Technical Bulletin

Model
1990-92
911 C2 Tiptronic

Subject: Engine Speed Sender Clearance
(Tiptronic Transmission)

Number
9301

Part Identifier
2873

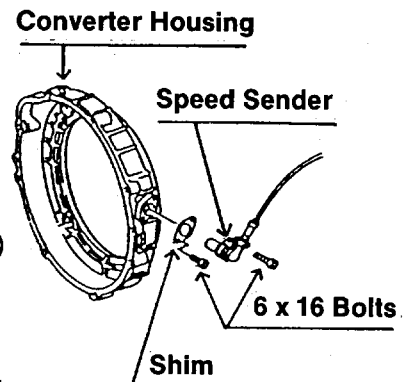
Concern: The air gap between the engine speed sender and the carrier plate sensing ring is adjustable. If the adjustment is not made correctly, damage to the sender and /or DME electronic control unit can occur.

General Information: If the shims for the speed sender have been lost or the speed sender has been changed during repair procedures, the air gap between the speed sender and the carrier plate sensing ring should be set and two new micro encapsulated bolts (Part Number 999 218 005 02) should be installed.

Some vehicles produced between 1990 and 1992 have only one bolt holding the sender to the converter housing. If this is noticed during repair procedures or vehicle inspection, the vehicle should have two new bolts (Part Number 999 218 005 02) installed.

During adjustment procedures, any combination of shims may be used to obtain the correct air gap ($1\text{mm} \pm .2\text{mm}$) between the sensing ring and speed sender.
